THE POTENTIAL IMPACT OF ART

March 8, 2016

WHY A.R.T. WILL LIKELY NOT MEET STATED GOALS

Figure 1 RIGHT OF WAY: Existing right of way width changes along Central Avenue.

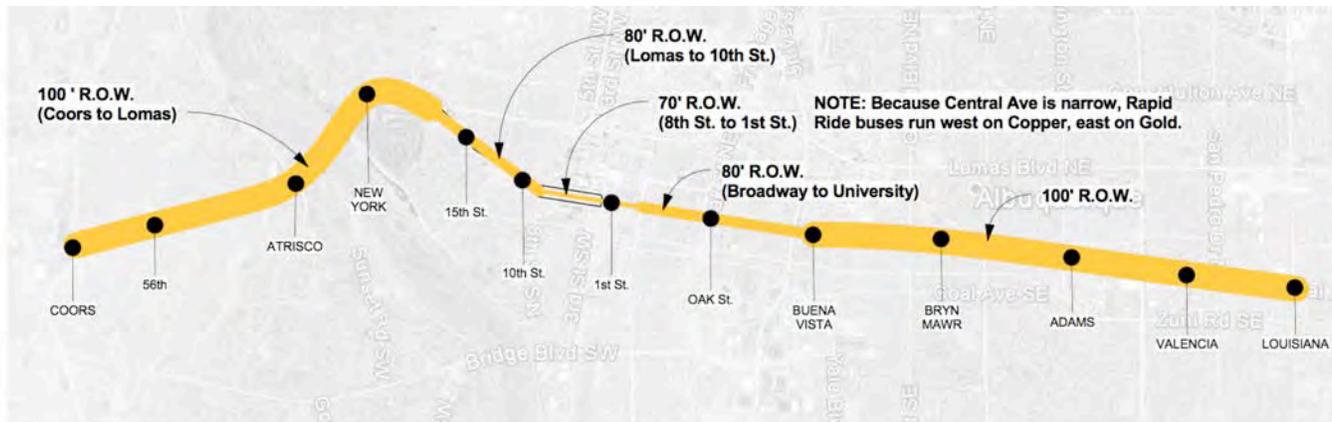
- **The squeezing** of automobile traffic lanes, bus lanes, bike lanes, rumble strips, trees, landscaping & sidewalks into a street corridor that is not wide enough to adequately accommodate this design, (See Figure 1 of Attached diagrams)

If built as designed, ART likely will not meet some primary components of Mayor Berry’s vision and the goals stated in the ART Plan, e.g. faster ride times & more predictable stop times. The basic problem arises from imposing a “one size fits all” design in right-of-ways that vary from 70 feet in Downtown to 100 feet in other areas. As presently designed, several historic neighborhoods along Central Avenue would be negatively impacted by changes in various aspects of the streetscape such as parking, bicycle lanes and trees. The following maps show where the right-of-way variations and other problems occur and how these negatively impact Central Avenue.

Figure 3 PARKING SPACES: 194 parking spaces would be lost as a consequence of ART.

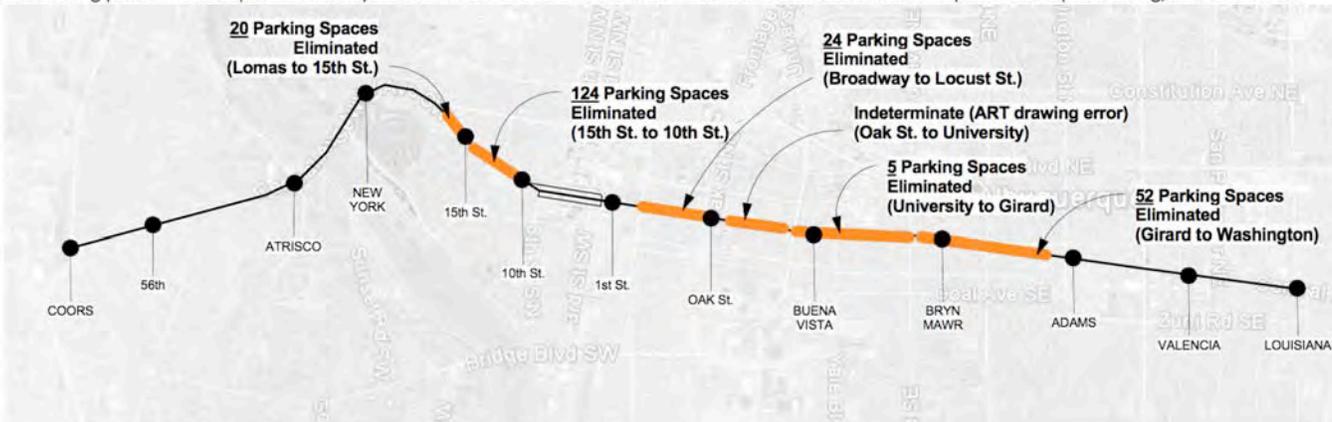
- **Elimination of +/- 194 parking spaces**, many in dense retail clusters of small, local businesses, (See Figure 3)
- **Removal of +/- 217 mature trees**, 40 of them in the short distance between Bryn Mawr and Adams in Nob Hill, plus removal of additional mature landscape, (See Figure 4)

- **Preservation of +/- 194 parking spaces** currently targeted to be eliminated between Old Town and Washington St.,
- **Preservation of +/- 217 mature trees** and landscaping currently targeted for elimination, and planting of additional trees & landscaping in the now-widened sidewalks,

Figure 6 TRAFFIC SIGNALS: From the ART Project plan drawings, 10 new traffic signals would be added to the 32 signals that currently exist on Central Avenue for a total of 42 signals on the 9-mile total Project length.

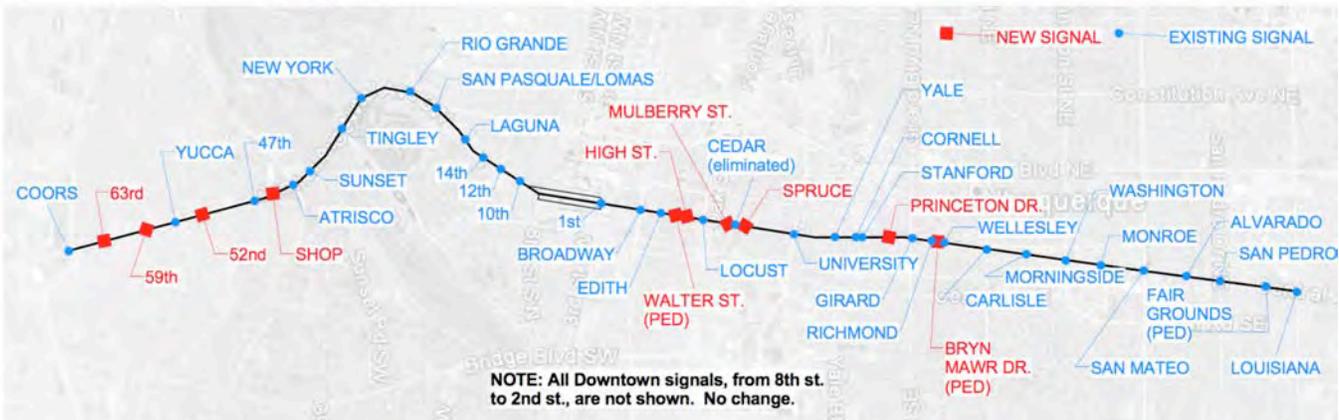
- **Addition of 10 new traffic signals**, for a total of 43 signals on the entire Central Avenue route, and increasing the number of phases to accommodate the new ‘bus-thru-first’ phase plus a separate “safe pedestrian crossing” phase for each of these signals, thereby likely causing further delay of ART buses, (See Figure 6)

Figure 7 LEFT TURNS: Approximately 241 left turns would be lost, which would severely restrict business accessibility on Central Avenue. This number includes left turns for westbound and eastbound traffic.

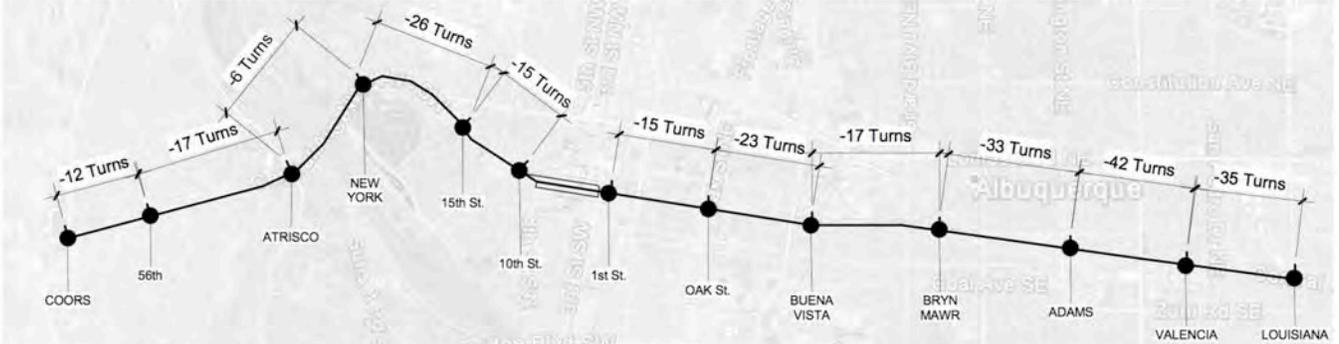
- **Significantly more difficult access** to Central Avenue & side street businesses and services due to elimination of +/- 241 left turns from side streets, parking lots, as well as both east and westbound lanes. (See Figure 7),

ART Project (as designed)

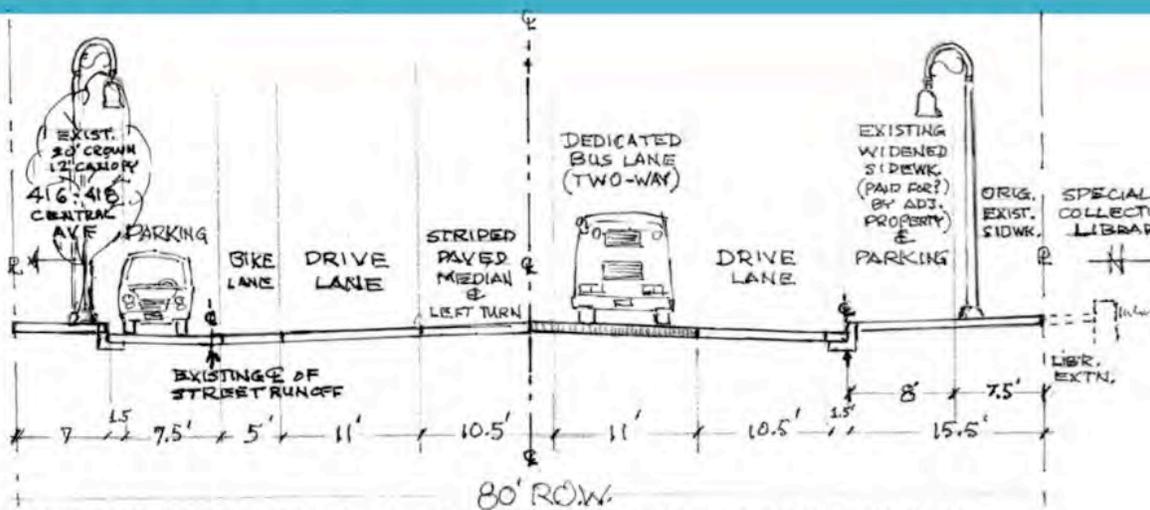
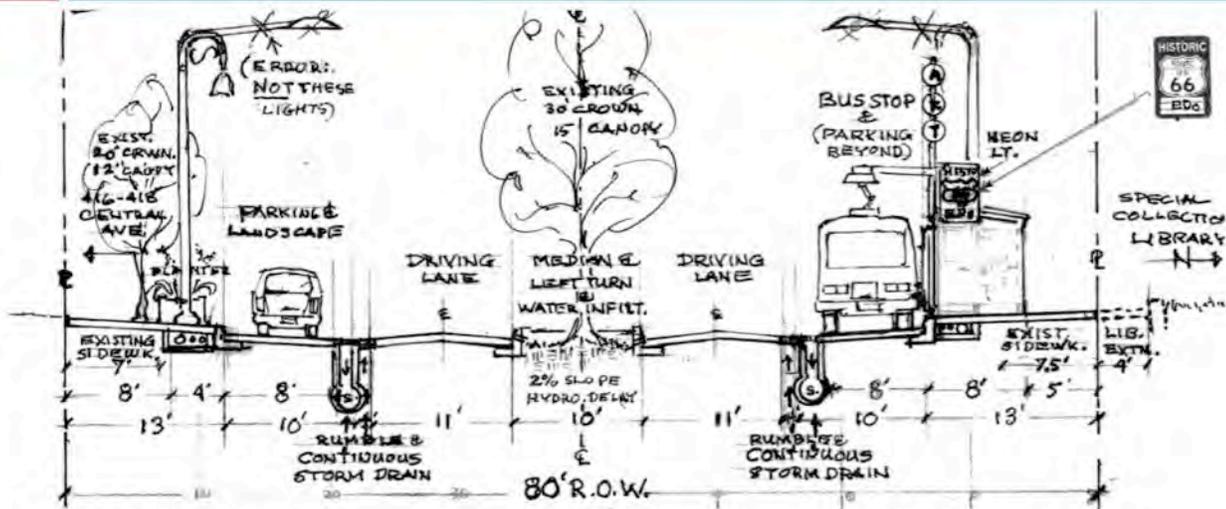
ALL EXISTING TREES WILL BE REMOVED. THERE IS NO PROVISION FOR WIDER SIDEWALKS OR STREETSCAPE ELEMENTS. SINGLE EAST AND WESTBOUND LANES WILL ACCOMMODATE RT 66 BUSES AND ALL OTHER VEHICLES. DIESEL BUSES ARE INDICATED.

CONCERNED CITIZEN'S PROPOSAL SHOWS THE SAME INTERSECTION WITH LANDSCAPE AND TREES DEFINING THE CHARACTER AND PEDESTRIAN NATURE OF THE DISTRICT. EXISTING STORM INLETS MAY NOT HANDLE INCREASED RUN OFF OF ART DESIGN. ELECTRIC BUSES ARE INDICATED.

ART Project (as designed)

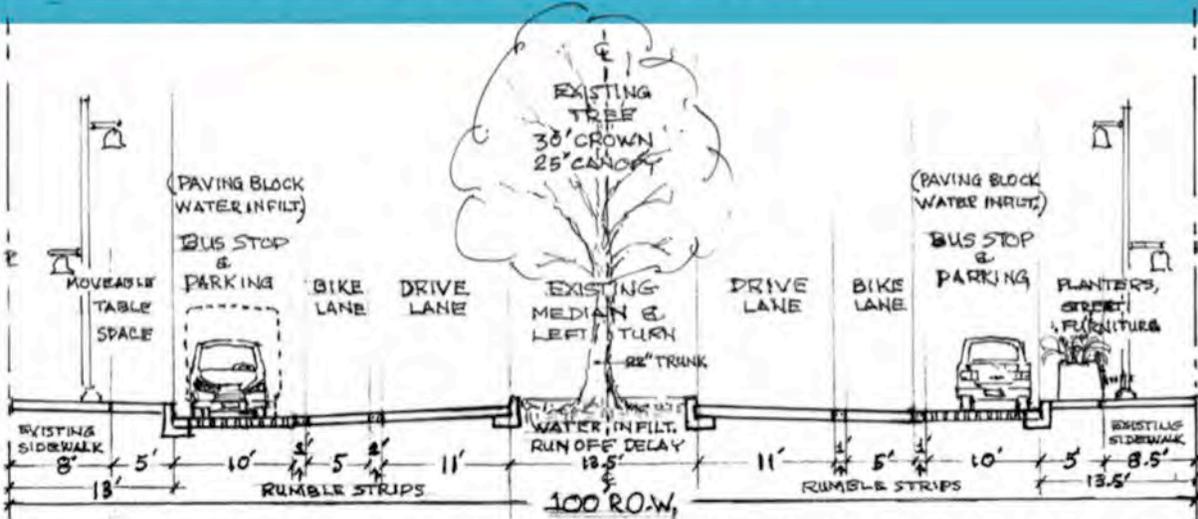
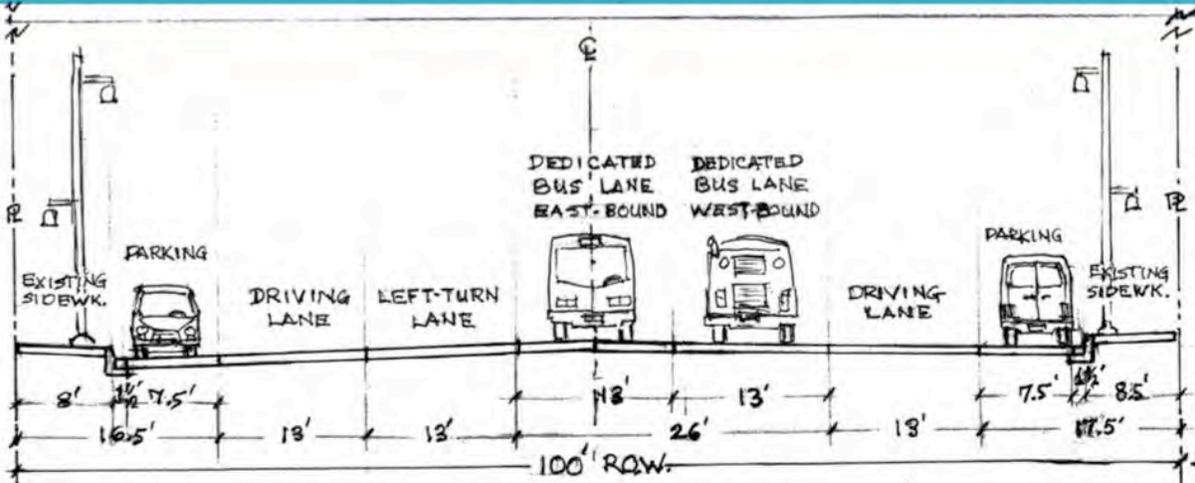
ALL MEDIAN TREES ARE REMOVED WITH NO LANDSCAPE SUBSTITUTIONS SHOWN. (THIS IS THROUGHOUT MOST OF NOB HILL). NO BIKE LANES ARE SHOWN. SIDEWALKS ARE NOT WIDENED EXCEPT FOR A FEW BLOCKS WEST OF SAN MATEO. NO SPACE FOR EMERGENCY RESPONDERS IS PROVIDED. INCREASED CAPACITY FOR WATER DRAINAGE/RUN OFF IS NOT SHOWN. DIESEL BUSES ARE INDICATED.

CONCERNED CITIZEN'S PROPOSED DESIGN FOR NOB HILL SHOWS WATER RUN OFF VOLUME AND VELOCITY REDUCED. BIKE LANES CAN BE USED BY VEHICLES IN SINGLE LANE TO ALLOW EMERGENCY RESPONDERS TO PASS. LANDSCAPE DEFINES THE SHOPPING AND PEDESTRIAN CHARACTER OF THE DISTRICT. ELECTRIC BUSES ARE INDICATED.

3) Tramway Blvd. Intersection - New Transit Station

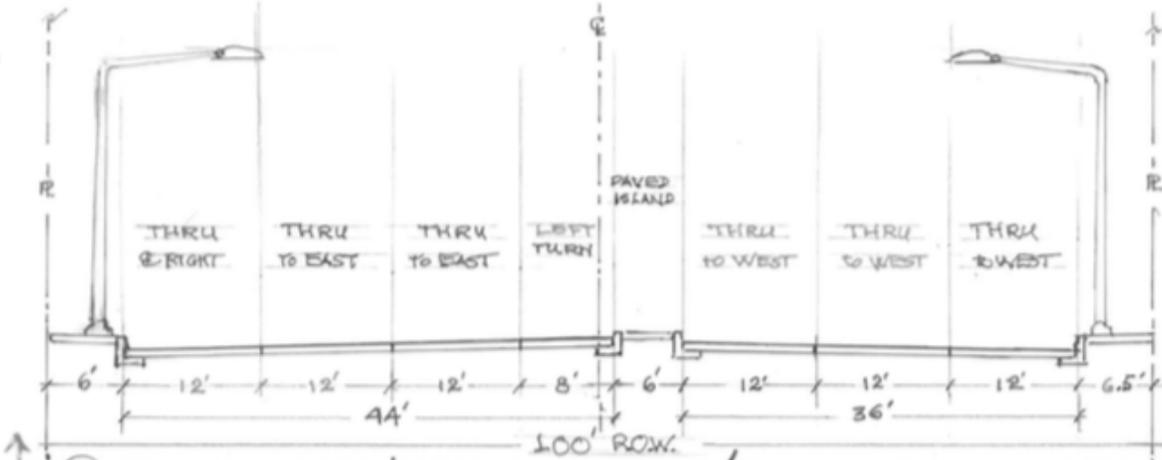
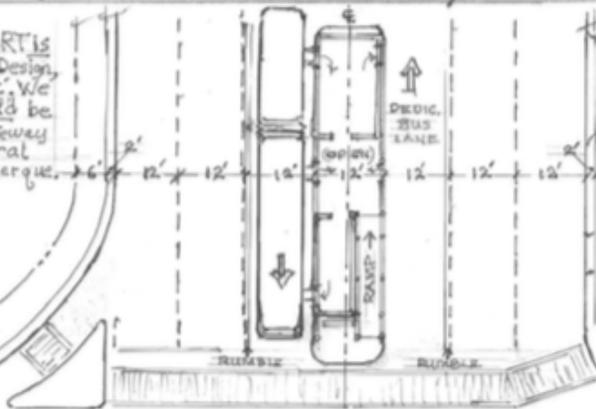
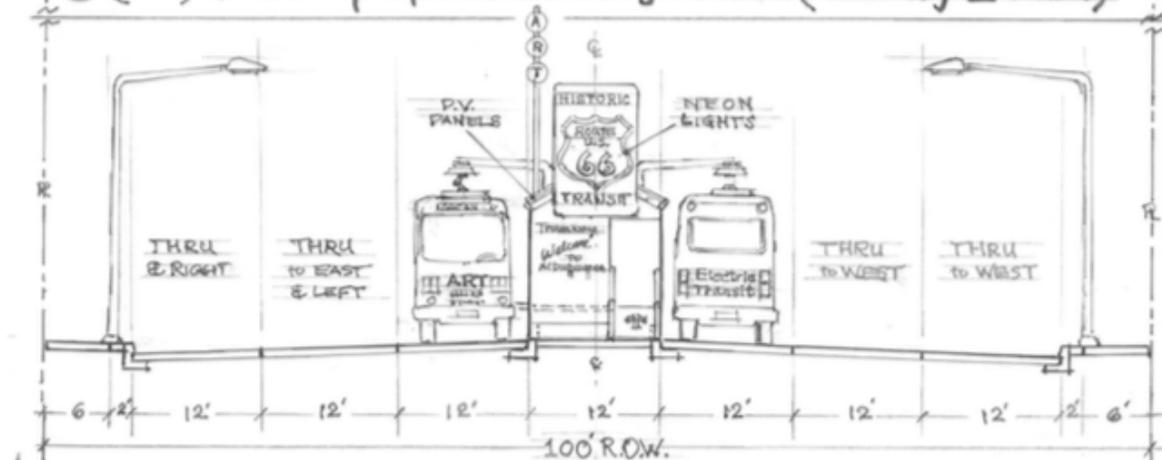
We believe that ART is a long-term Urban Design, not just a Transit. We propose that it could be the Welcoming Gateway to the rich cultural diversity of Albuquerque.

- **Include an iconic and memorable “Gateway” ART station** and welcoming entrance to Albuquerque from the East at Tramway and from the West at Unser? (See attached rendering, Example #3) NOTE: This assumes that there would be a cost savings as a result of implementing the simplified, less utility-disrupting, curbside design recommended above in some sections of Central Ave. (See attached cross-section examples) The extension of ART from Louisiana to Tramway and from Coors to Unser would create a “complete” ART Transit corridor, and a clear basis to allow economically sound decisions regarding station locations and appropriate development decisions at key station locations. As presently designed, starting at Coors on the West and Louisiana on the East, the “complete system design” seems unclear, deterring sound development location decisions. It would be prudent to extend ART even if there were no significant cost savings from the recommended design modifications.

We also believe that the cost savings by using the C.C.G. sections in 1 & 2 could allow extending the dedicated Center-Lane portion to Tramway & Unser.
